Statement of Response to the Notice of Pre- Application Consultation Opinion

Strategic Housing
Development at Trusky
East, Trusky West,
Freeport and Ahaglugger,
Berna, Co. Galway

Figure 10: Phasing Proposal

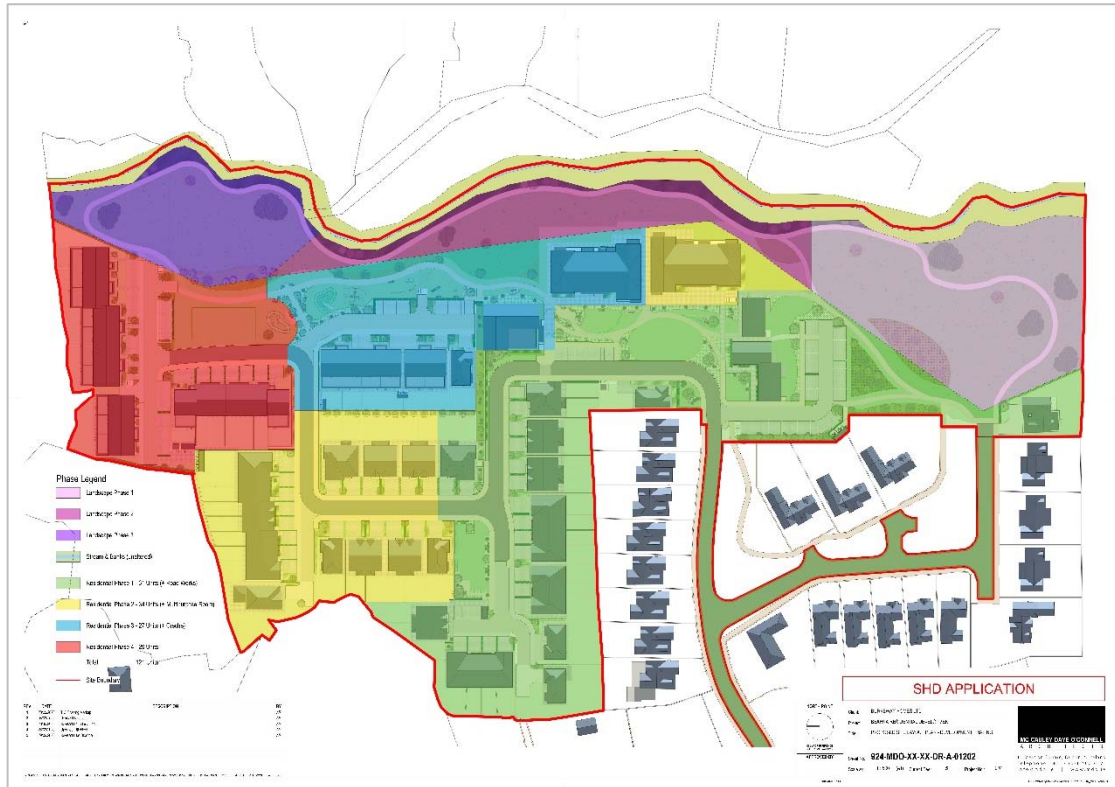
7. *A phasing plan for the development.*

MDO Architects in collaboration with the applicant have prepared a phasing plan for the proposed scheme, as detailed in Figure 10 below. Please refer to **Dwg 924-MDO-XX-XX-DR-A-01202 Proposed Site Layout Development Phasing**, for further details. It is envisaged that the scheme will be developed in 4 no. stages, with proportionate amounts of communal open space provided in each phase. The proposed childcare facility will be provided in Phase 3, with a total of 52 units being delivered in Phase 1 (31 units) and Phase 2 (21 units).
